Subject: Replacement of Hotellier-Quicklinks of the elevator system

Effectivity: Sailplane ASTIR CS:
all Serial-N^o. from 1001.
Sailplane ASTIR CS 77:
all Serial-N^o. from 1601.
Sailplane ASTIR CS JEANS:
all Serial-N^o. from 2001.

Detail N^o. 1

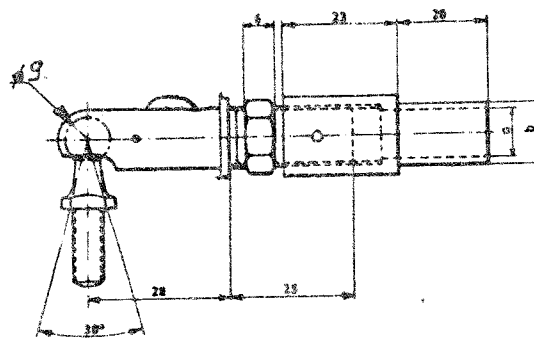
Correct joint with normal swivel-housing and wedge-type slide R 9.41.

Step 2. If not yet installed, cam-type links R9.45. (detail N^o. 2) or Z-housing links (open housing) RZ 9.41. (detail N^o. 3) must be replaced by links R9.41. (detail N^o. 1) with closed housing and wedge-type slide. Swivel N^o. 961 M has to be also replaced by a new one.

Detail N^o. 2

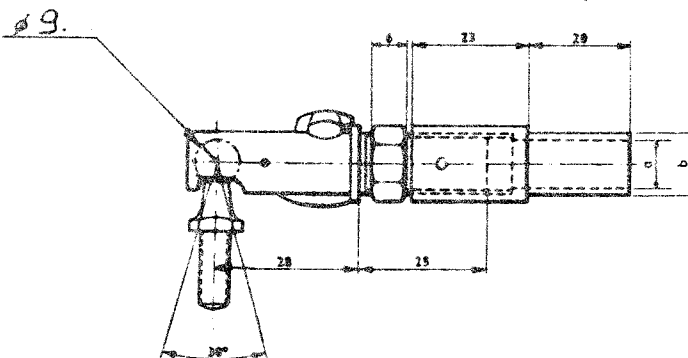
not permitted joint with cam-type lock R 9.45.
